METROPOLITAN GOVERNMENT OF NASHVILLE AND DAVIDSON COUNTY

STAFF RECOMMENDATION
945 S Douglas Avenue, Unit #5
May 19, 2021

Application: New Construction – Infill/Part II SP
District: Waverly-Belmont Neighborhood Conservation Zoning Overlay
Council District: 07
Base Zoning: SP
Map and Parcel Number: 105130289.00
Applicant: Martin Wieck, Nine12 Architects
Project Lead: Jenny Warren, jenny.warren@nashville.gov

Figure 5. Roof plan

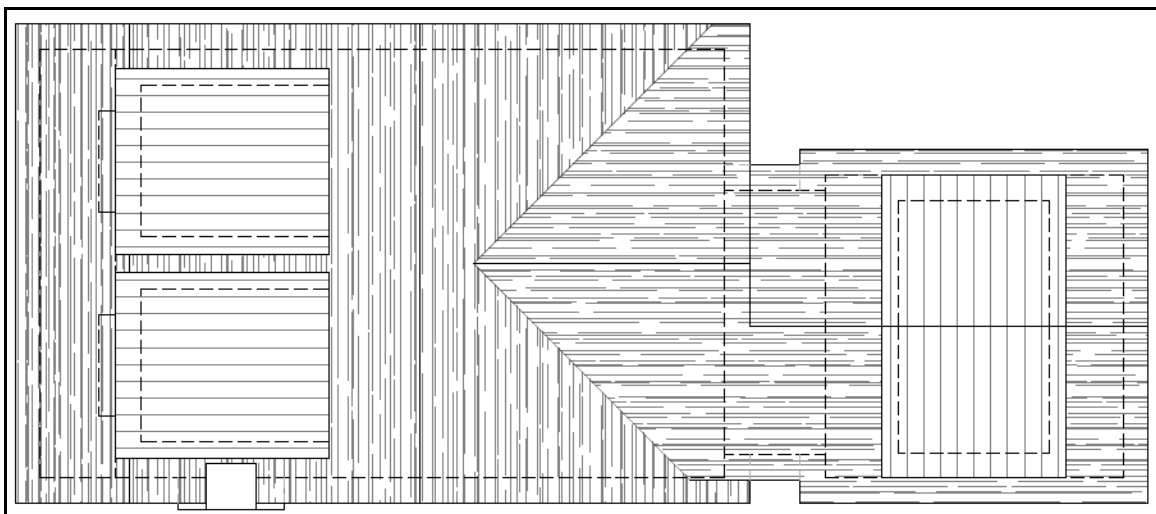
Roof Shape: The design incorporates a primary side facing gable with lower rear-facing gables on the back. These all have a 9/12 slope. There are appropriately inset shed roofed dormers on the front elevation and on either side of the attached garage. Staff finds that this side-gabled roof form contributes to the variety of forms on the site, which the Commission had requested as a part of the initial SP approval.

Staff finds that the proposal meets section III.E for roof shape.

Figure 6. Rear elevation

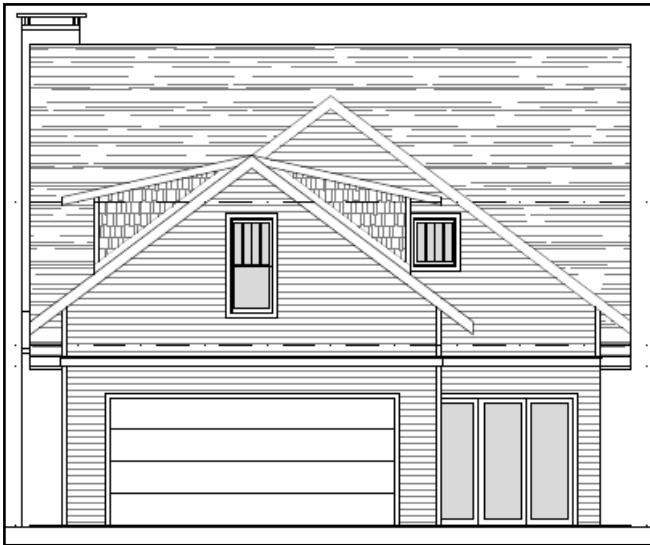
from the part I SP application show the attached garages for the thirty-five foot (35') tall one-and-a-half story units #1-#7 as subservient in height. The proposed attached garage has a ridge height of approximately twenty-three feet (23') from grade and an eave of approximately twelve feet (12'). Staff finds that the proposed massing, which keeps the garage roof lower and subservient, while keeping the eave height similar to that of the house, is consistent with the SP approval.

Staff finds that the proposed attached garage is consistent with the massing and site plan of the approved SP.

SP SITE PLAN

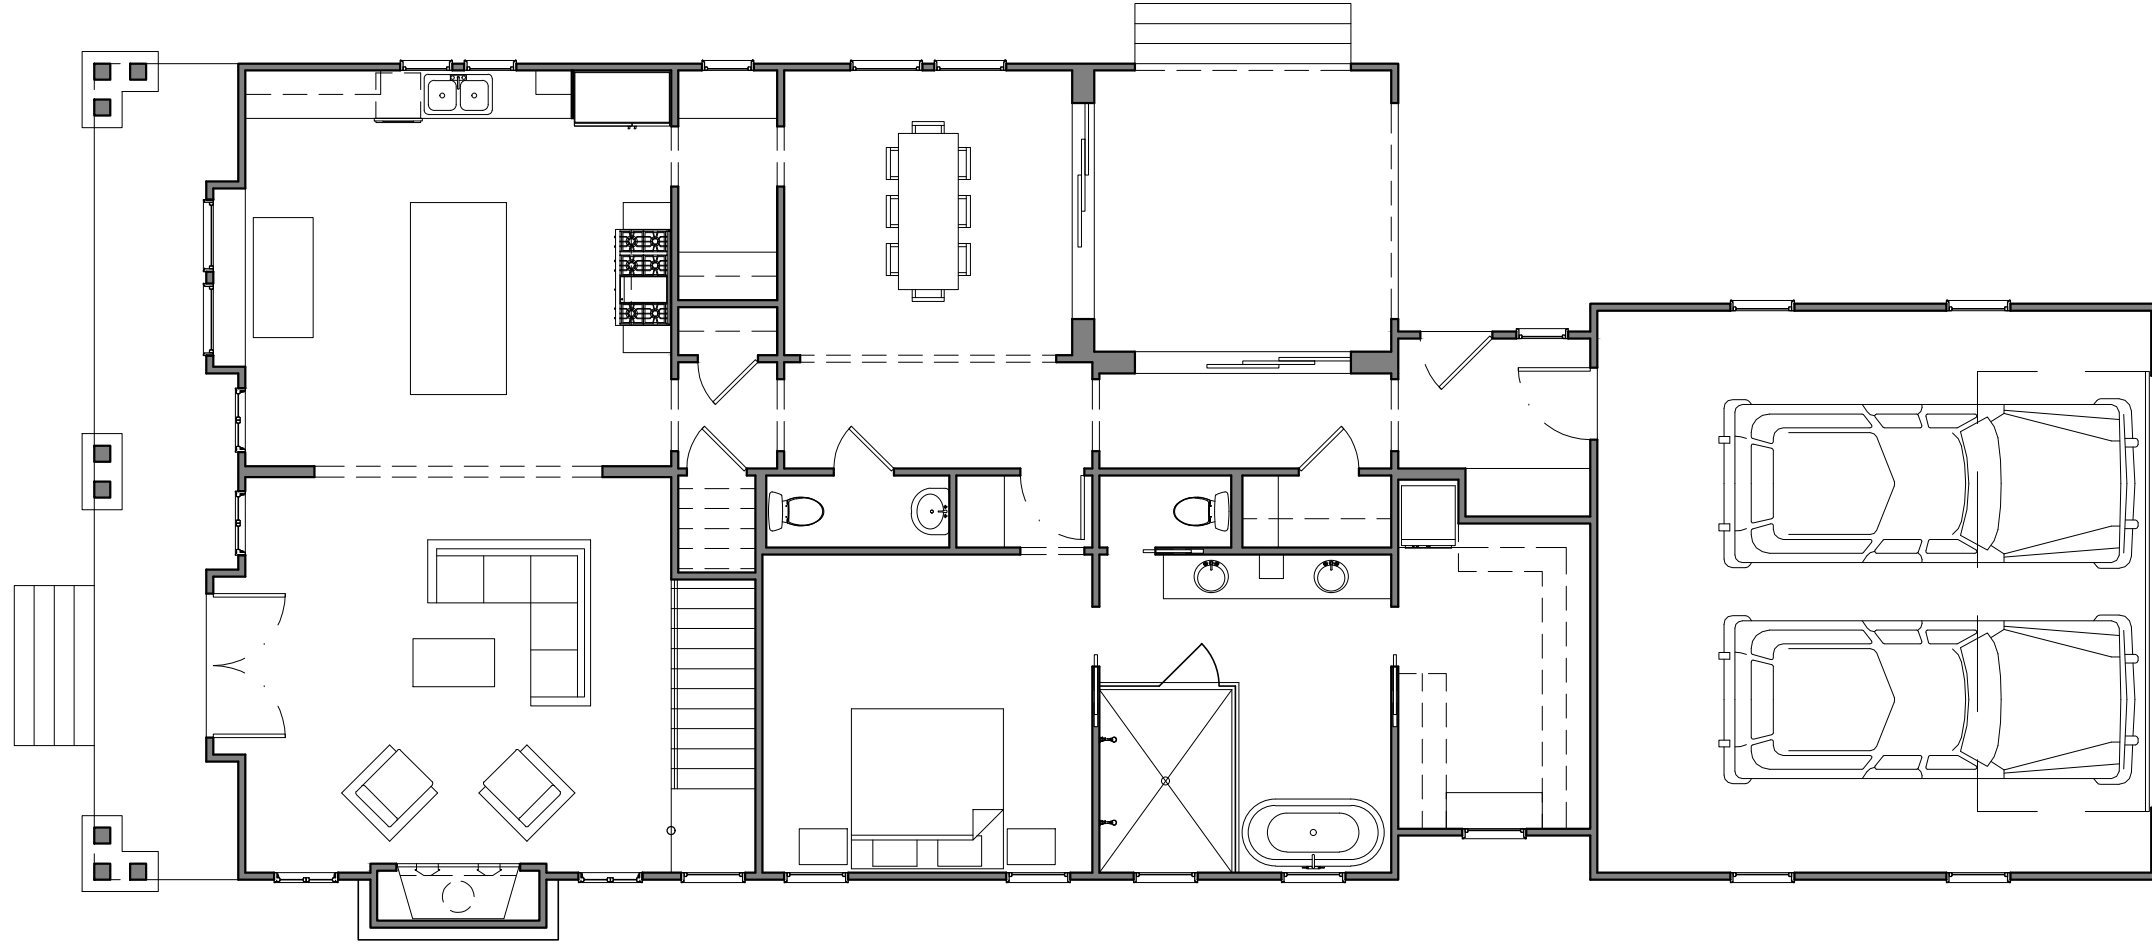
Setback & Rhythm of Spacing: The infill will be sited as per the approved part I SP. (Figure 1) This house will have a twenty-foot (20') front setback, as do all of Units 1-7. These houses will mostly be about twenty-five feet (25') apart at the front and will come closer further back, due to the curve of the parcel.

Units #4 and #5 will have the typical twenty-five feet (25') of separation at the front and will be about eleven feet (11') apart at the back corners. The rear corners of the garage are very close at about six feet (6'). All structures must be at least six feet (6') apart to meet fire code requirements. Units #5 and #6 will be about thirteen feet (13') apart at their closest points. This is consistent with the SP site plan.

The project meets the SP approval and section III.C for setback and rhythm of spacing for new construction.
